Quad ISDN 2B1Q Echocanceller Digital Front End

DFE-Q V2.1

PEF 24911 Version 2.1

This Delta Sheet lists the add-on features and differences between the DFE-Q V2.1 and the DFE-Q V1.3.

Figure 1   Pin Diagram of the DFE-Q V2.1

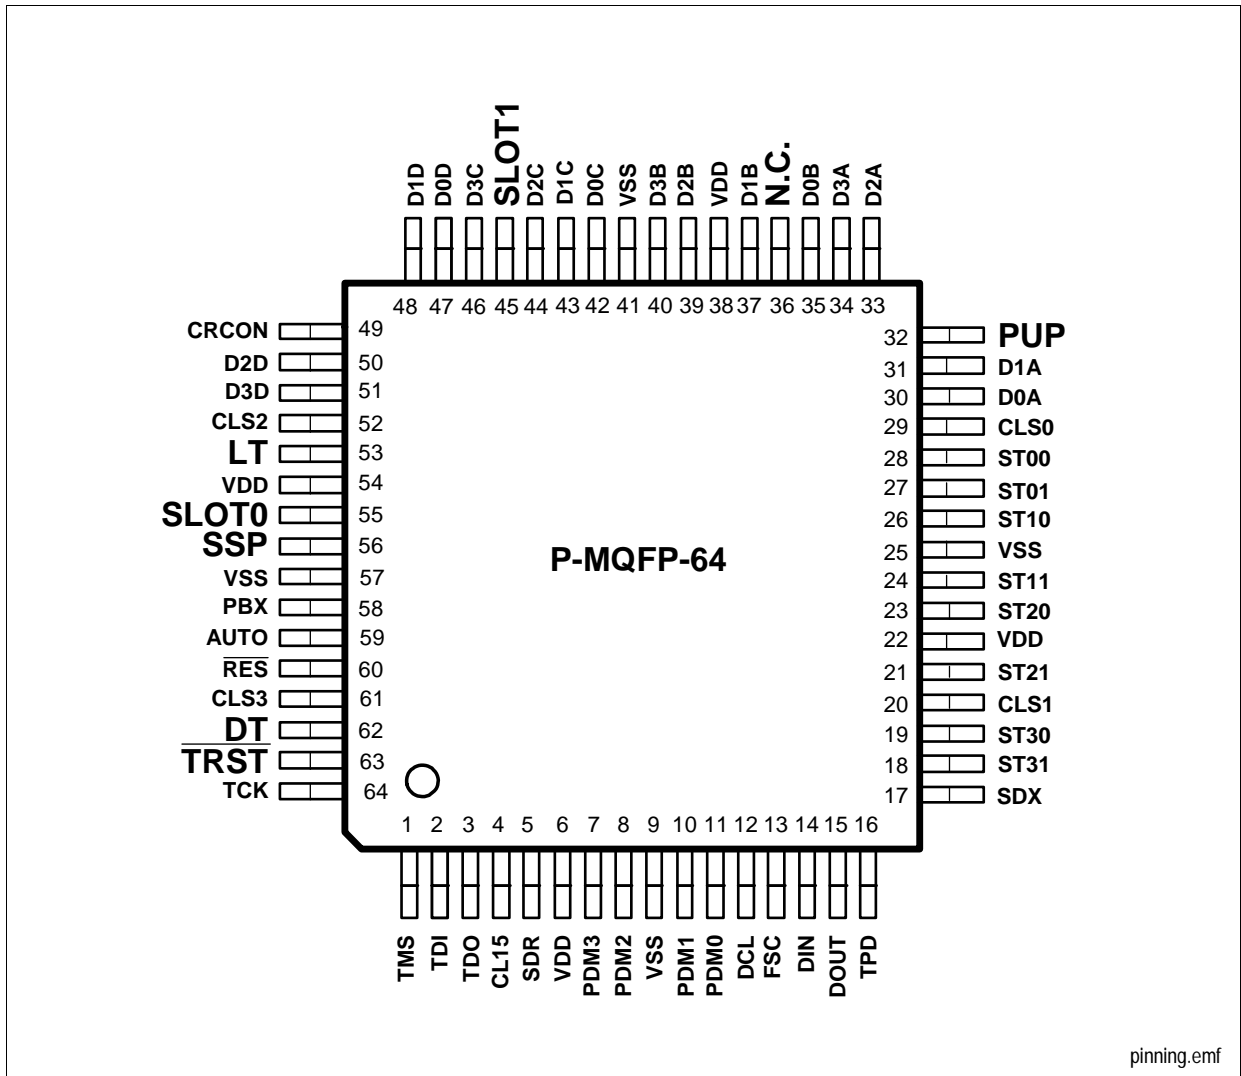
Table 2 lists the changes that were made concerning the pinning, **Table 3** specifies new pin functions that were introduced with version 2.1.

32	PUP	N.C.	additional push-pull mode for pin DOUT eases interface adaptation
36	n.c.	DSYNC	obsolete
55	SLOT0	SLOT	renamed
45	SLOT1	N.C.	increased max data rate (4 MBit/s) requires an additional SLOT pin
53	LT	LT	dedicated LT mode pin is obsolete
56	SSP	TSP	dedicated pin for 'Send Single Pulses' test mode
58	PBX	PBX	function removed
62	DT	TP	dedicated pin for 'Data Through' test mode
63	TRST	TP1	BScan power-on-reset is replaced by a dedicated reset line

Figure 2 **Loopbacks Featured by Register LOOP**

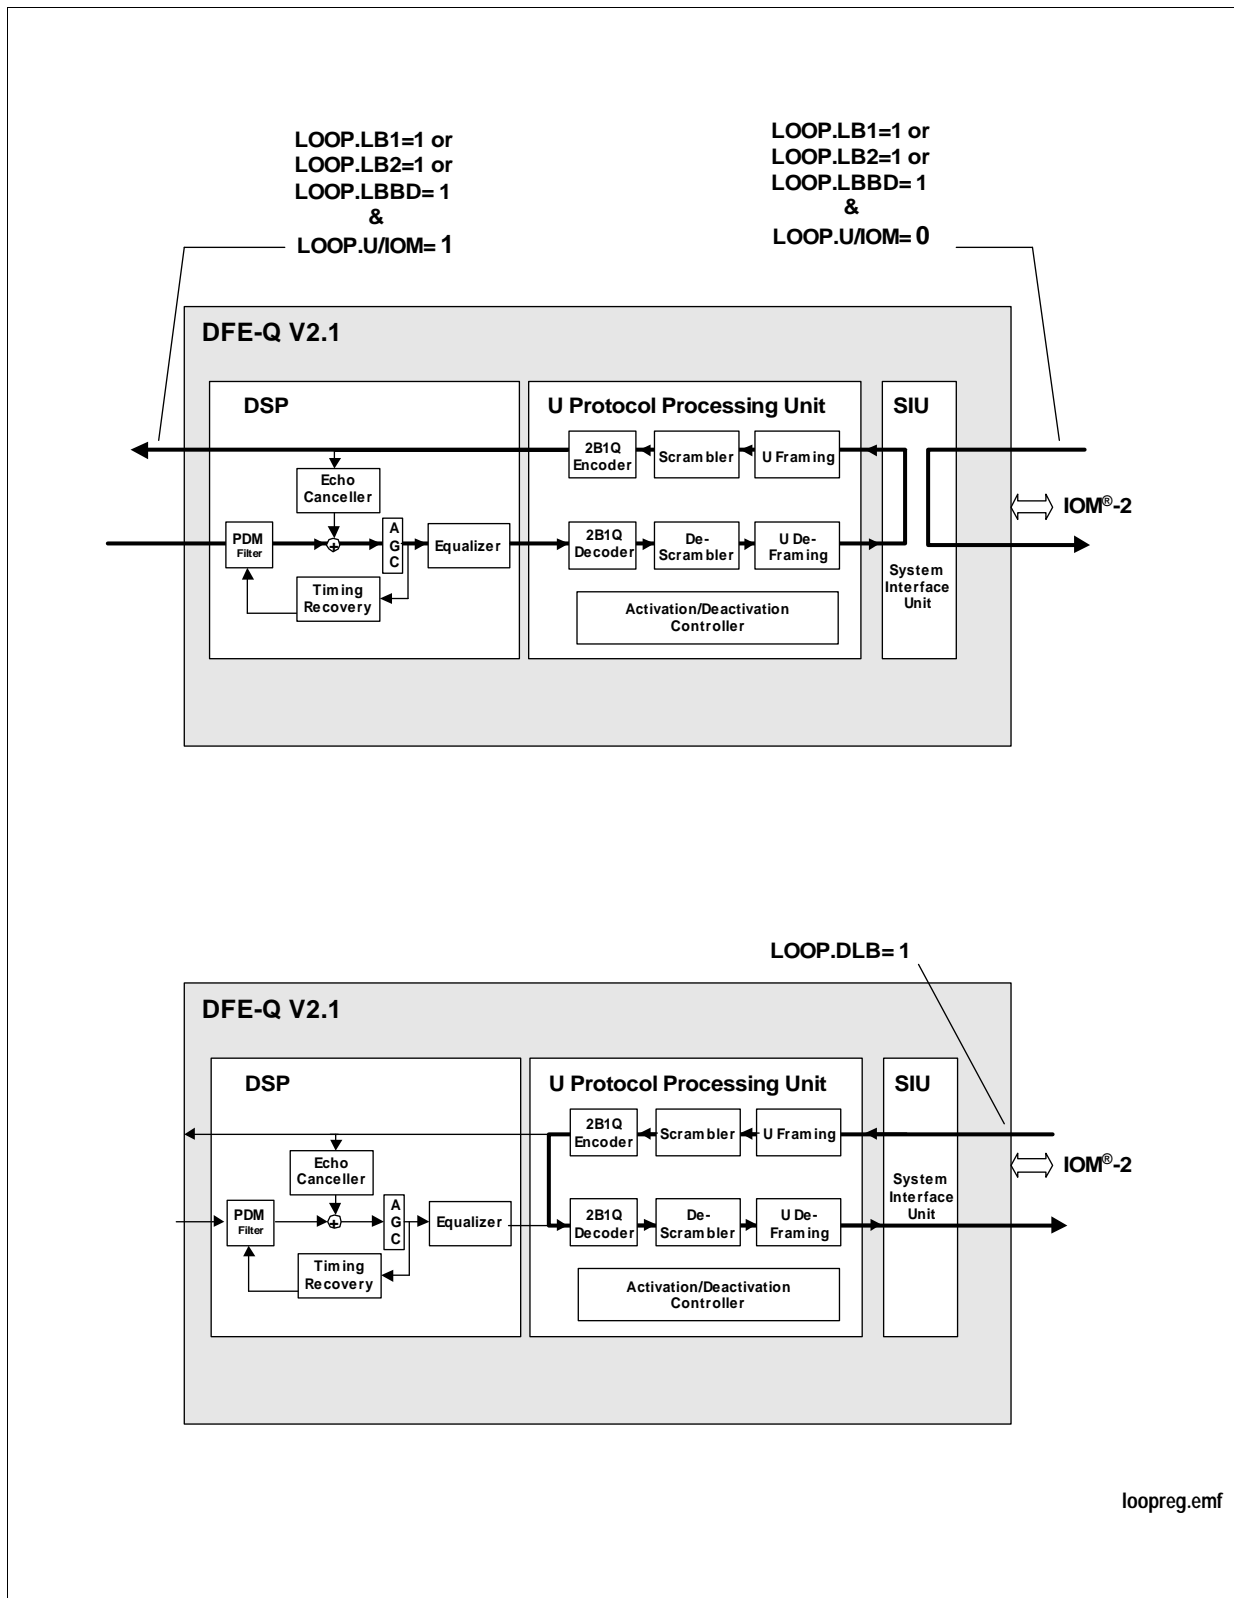
Besides the remote loopback stimulation and the local analog loopback (C/I= ARL) the DFE-Q V2.1 features digital local loopbacks via its internal register set. The local loopbacks that are additionally provided by the LOOP register are shown in **Figure 2**. The local loops can be activated at any time independent of the current activation status using the MON-12 protocol.

Figure 3   State Diagram of V2.1

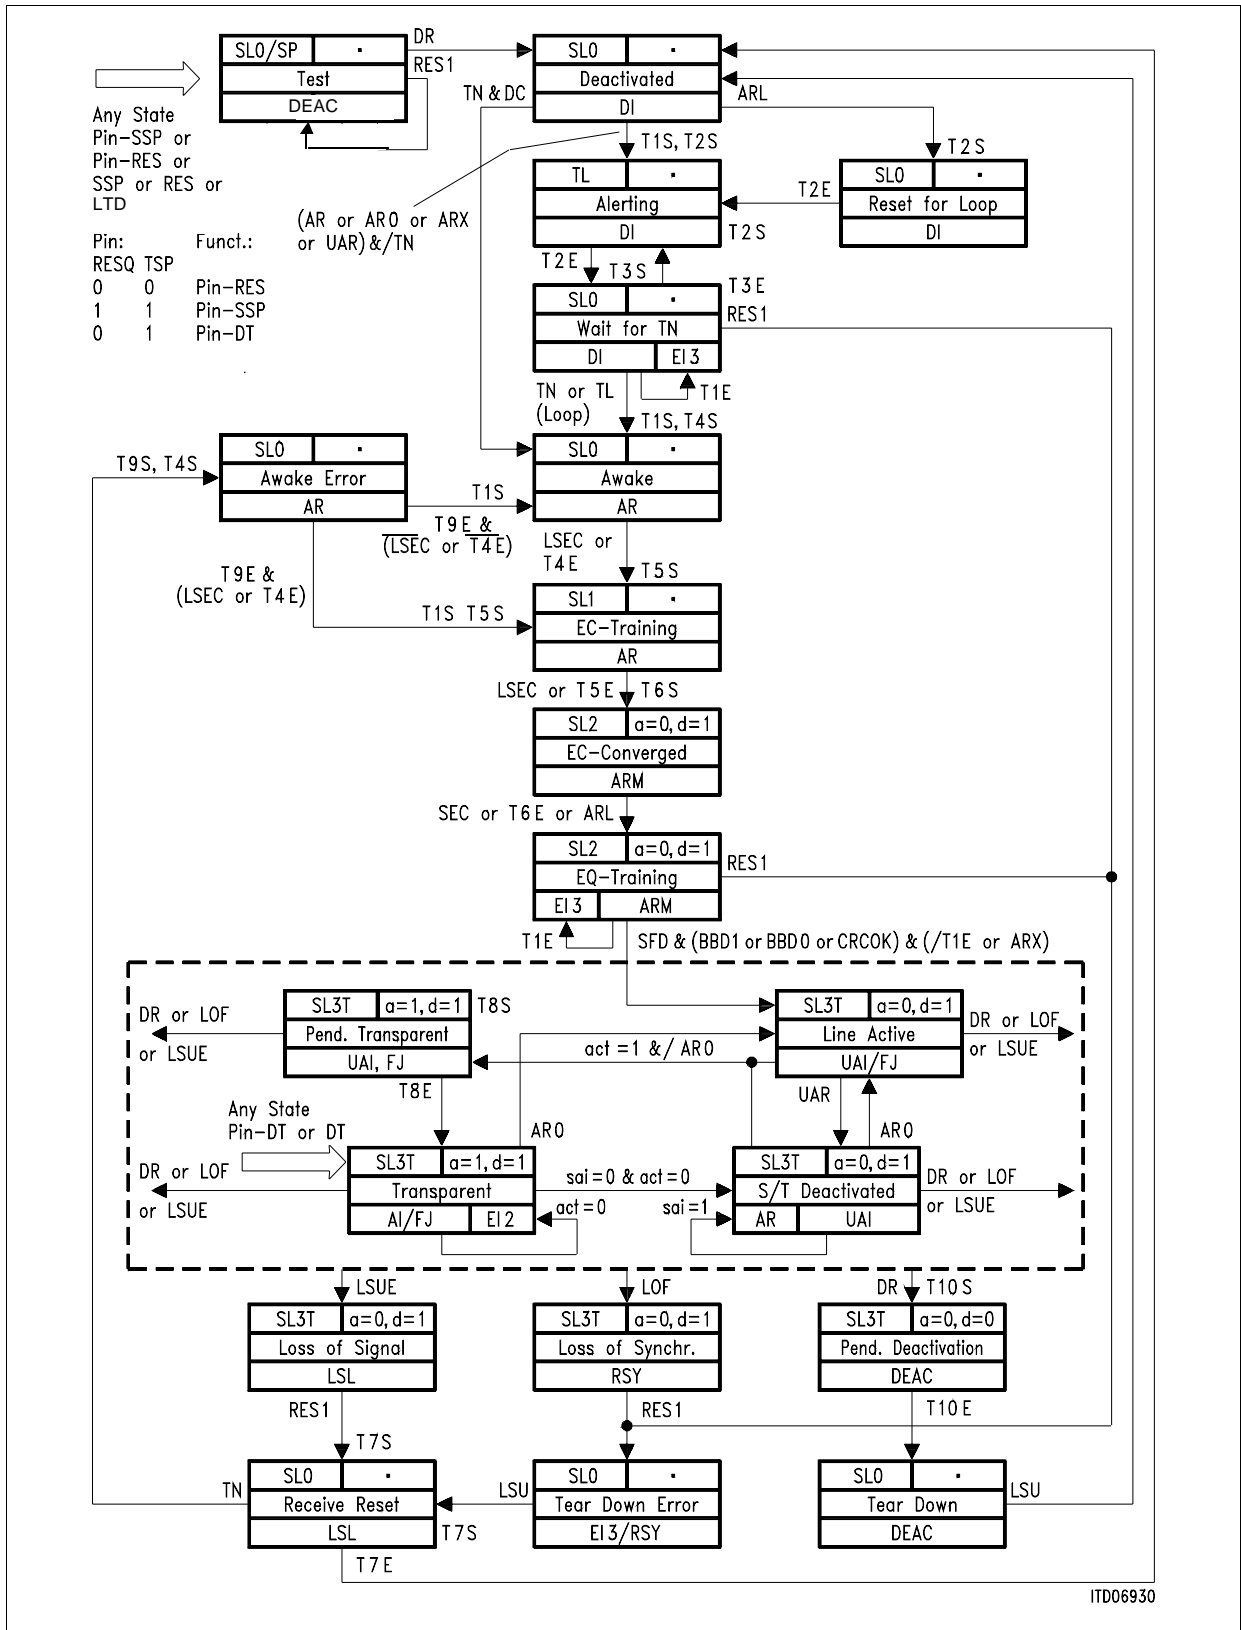
Some minor changes were made regarding the state machine. The improvements are summarized and listed in **Table 4**. See also the state diagrams in **Figure 3** (V2.1) and **Figure 4** (V1.3).

No.	V1.3 State/ Signal	Change in V2.1	Comment
1.	'Test' State	split into two states - Reset State - Test State	defined reset and test states
2.		state 'Alerting Error'	introduced for a clear separation of the normal operation state from the error condition state (which will result in a deactivation)
3.	state 'Transparent'	C/I code output in state 'Transparent' dependent on received act bit	
4.	state 'S/T Deactivated'	C/I code output in state 'S/T Deactivated' dependent on sai bit status	
5.	C/I code LTD	C/I code 'LTD' is omitted	function corresponds to that of C/I 'RES'
6.	C/I code INT	C/I code 'INT' is not supported	INT was listed in former documents of V1.x due to an editorial fault
